HISTORIC AND DESIGN REVIEW COMMISSION

May 07, 2025

HDRC CASE NO: 2025-110
ADDRESS: 2602 N FLORES ST
LEGAL DESCRIPTION: NCB 1865 BLK 39 LOT S 83.34 FT OF 11 & 12
ZONING: IDZ-1, H
CITY COUNCIL DIST.: 1
APPLICANT: Austen Kernodle/HiWorks
OWNER: Jason and Christi Willome/WILLOME JASON P & CHRISTI
TYPE OF WORK: Exterior Modifications & Rear Accessory Structure
APPLICATION RECEIVED: April 22, 2025
60-DAY REVIEW: June 21, 2025
CASE MANAGER: Caitlin Brown-Clancy
REQUEST:

The applicant is requesting a Certificate of Appropriateness for approval to:

Proposed Site Plan

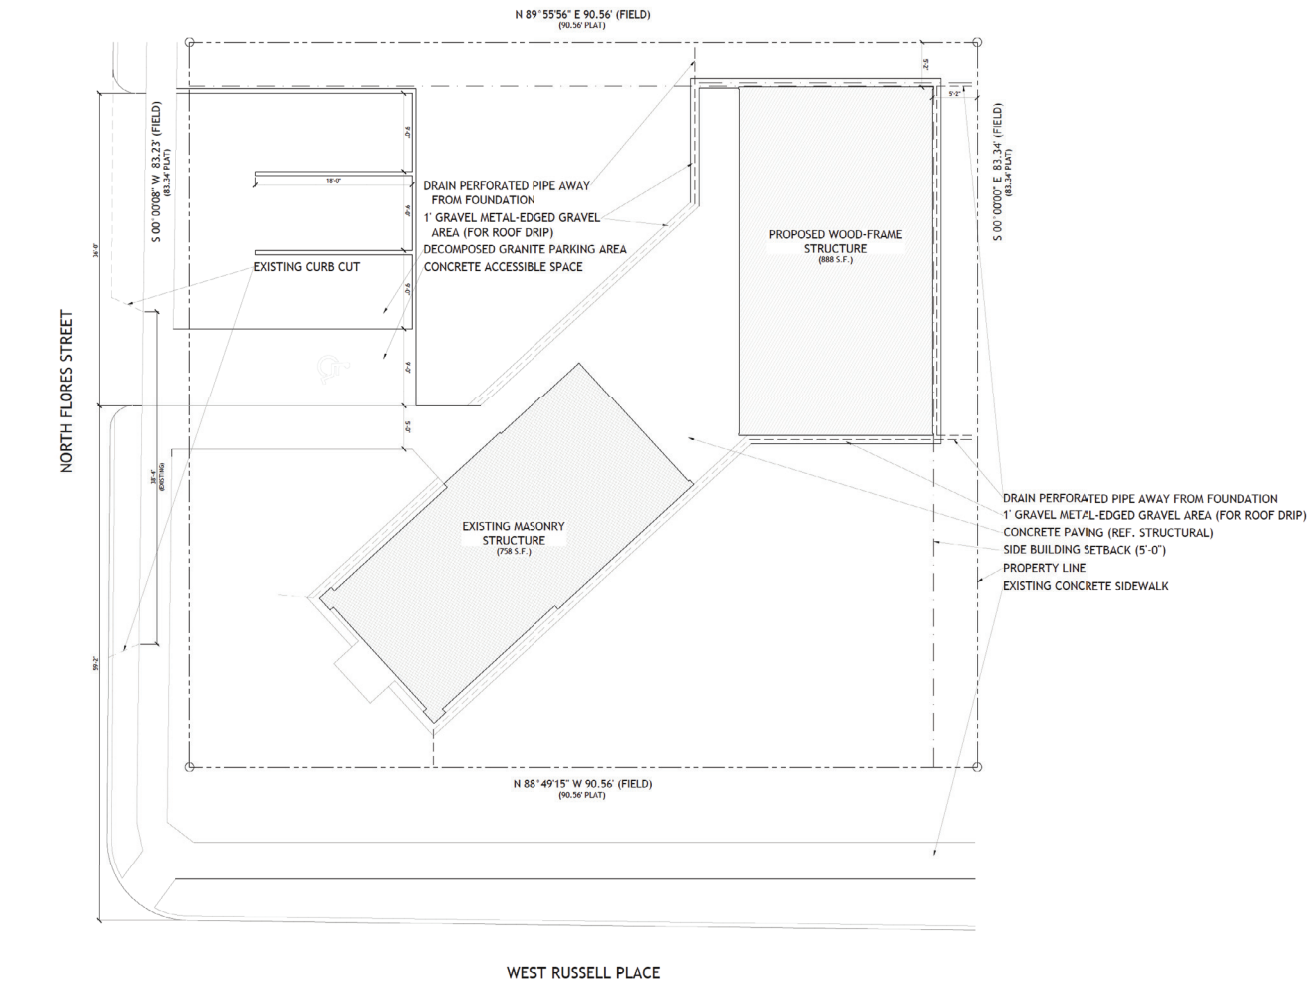
- i. **LANDSCAPING AND SITE ELEMENTS**– To date, the applicant has not submitted any landscaping plans though drawings/renderings suggest conceptual plantings as well as demo of existing flatwork and installation of new flatwork. Additionally, the applicant has proposed to install a horizontal composite wooden fence along the Eastern edge of the proposed parking area. Staff finds the applicant should submit a comprehensive site plan indicating any proposed planting specifications, dimensions of proposed walkways/flatwork and material and height specifications for the proposed fencing to staff for review prior to the issuance of a COA.

- a. That the applicant submit a comprehensive site plan indicating any proposed planting specifications, dimensions of proposed walkways/flatwork and material and height specifications for the proposed fencing to staff for review prior to the issuance of a COA based on finding a and i.

Proposed Elevations (Existing Structure)

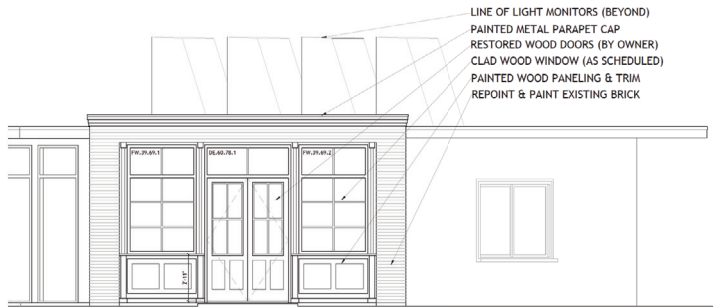
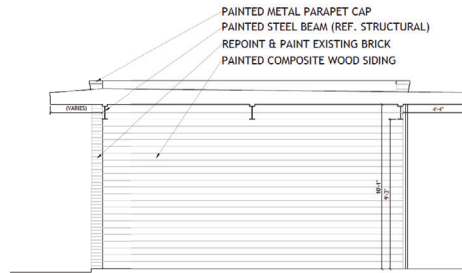
- c. FENESTRATION MODIFICATIONS: FRONT FACADE – The applicant has proposed to modify the fenestration pattern on the front façade of the original structure to feature a storefront window system with central double entry doors, flanked by two Jeldwen Epicvue clad wood windows on each side. The applicant has proposed to install two fully wood restored doors and wooden paneled bulkheads on the front façade beneath the fixed windows. Guideline 6.A.i for Exterior Maintenance and Alterations states that applicants should preserve existing window and door openings. Avoid enlarging or diminishing to fit stock sizes or air conditioning units. Avoid filling in historic door or window openings. Avoid creating new primary entrances or window openings on the primary façade or where visible from the public right-of-way. Staff finds that the existing fenestration on the front façade is not original to the structure and the proposal is generally appropriate, however, find the applicant should submit manufacturer specifications of the windows to staff for review prior to the issuance of a COA.

3 **NORTHWEST ELEVATION**

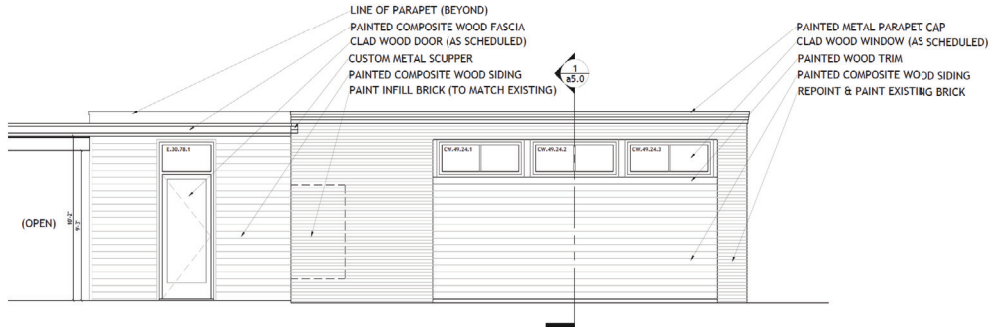
- d. FENESTRATION MODIFICATIONS: NORTHWEST ELEVATION – The applicant has proposed to modify the fenestration pattern on the NW elevation to feature a row of Jeldwen Epicvue transom/clerestory windows to match the existing openings on the SE elevation and a new entrance at the NW corner. The NW elevation will also feature Composite wood siding. Guideline 6.A.i for Exterior Maintenance and Alterations states that applicants should preserve existing window and door openings. Avoid enlarging or diminishing to fit stock sizes or air conditioning units. Avoid filling in historic door or window openings. Avoid creating new primary entrances or window openings on the primary façade or where visible from the public right-of-way. The existing elevation features a boarded central opening, a transom window opening without windows, and one boarded window opening. The existing elevation features an inset from the brick façade. Staff finds the proposal generally appropriate and finds that the applicant should submit window and door manufacturer specifications for review and that the proposed cladding should retain the existing inset and should be recessed at least 1-2 inches from the brick façade.

4 **SOUTHEAST ELEVATION**

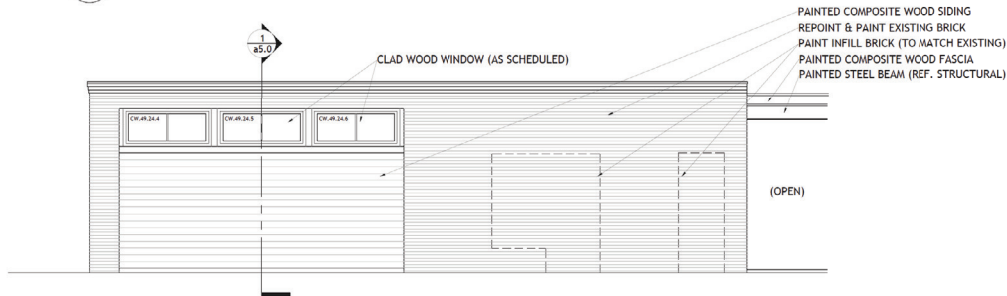
- e. FENESTRATION MODIFICATIONS: SOUTHEAST ELEVATION – The applicant has proposed to modify the fenestration pattern on the east elevation to feature a row of Jeldwen Epicvue transom/clerestory windows. The east elevation will also feature composite wood siding. Guideline 6.A.i for Exterior Maintenance and Alterations states that applicants should preserve existing window and door openings. Avoid enlarging or diminishing to fit stock sizes or air conditioning units. Avoid filling in historic door or window openings. Avoid creating new primary entrances or window openings on the primary façade or where visible from the public right-of-way. The existing elevation features a boarded central opening, a clerestory opening without windows, and two boarded door openings. The existing elevation features an inset from the brick façade. Staff finds the proposal generally appropriate and finds that the applicant should submit window and door manufacturer specifications for review and that the proposed cladding and mural should retain the existing inset and should be recessed at least 1-2 inches from the brick façade.
